Title:	STX40/LPX40 Shaker Wiring Change V6.0 to V6.1	ID:	
		0020	
Date in:	Response:	Model:	Author:
2007-05-24	2007-05-24	STX40 / LPX40	CMA

STX40 / LPX40 Shaker Wiring Change V6.0.xx to V6.1.xx

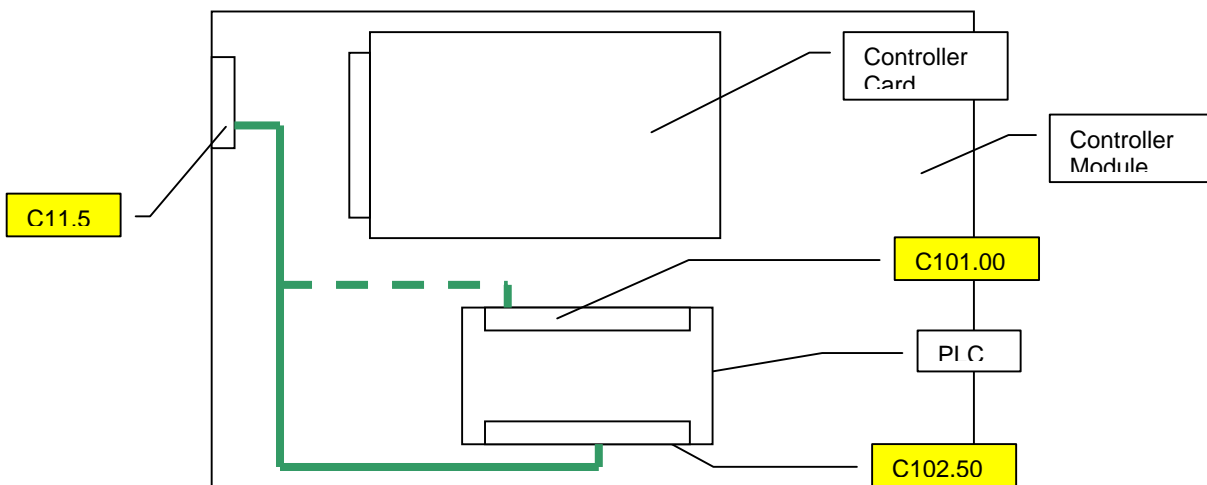
1. Remove wire from C103.30 (37 Pin connector on controller card) to C101.000 (PLC input 000)

2. Locate wire from C11.5 (9-pin D-Sub shaker connector) to C102.504 (PLC output 504)

3. Remove end of wire at S102.504 (output PLC 504) and put to C101.000 (input PLC 000)
